IMPORTANT NOTICE

INTERSPIRO July 15, 2016

DESCRIPTION

Figure One - Female Coupling

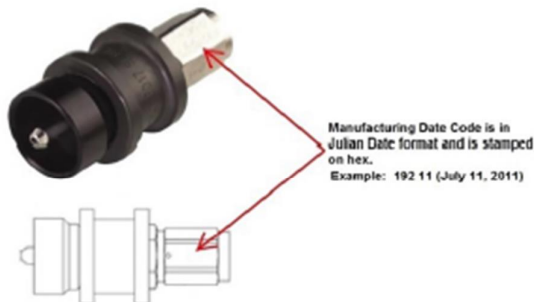
Female Coupling (see Figure 1)

March 1, 2015 through January 31, 2016

Date codes from 061 15 through 031 16.

Male Coupling (see Figure 2)

March 1, 2015 through August 31, 2015

Date codes from 061 15 through 214 15.

Note: If the date code stamped on the coupling contains six digits, use only the first five digits to determine the date code of the coupling.

An S4 through S8 series SCBA with a RIC UAC male coupling or a RIT Rescue Pack with a RIC UAC female coupling identified in the affected ranges may temporarily remain in service until the coupling is replaced provided a connection test is performed to determine whether a cup seal blow out condition exists.

A successful connection test indicates the male or female RIC UAC coupling can remain in temporary service. This test must be performed after every use of the RIC UAC coupling to determine if the SCBA or RIT Rescue Pack should continue in service. However, any male or female RIC UAC coupling with a date code within the range specified in this Campaign Bulletin must be replaced as soon as possible.

Any RIC UAC male/female couplings found to have date codes listed in this notice will be replaced under warranty. Contact Interspiro for replacement couplings.
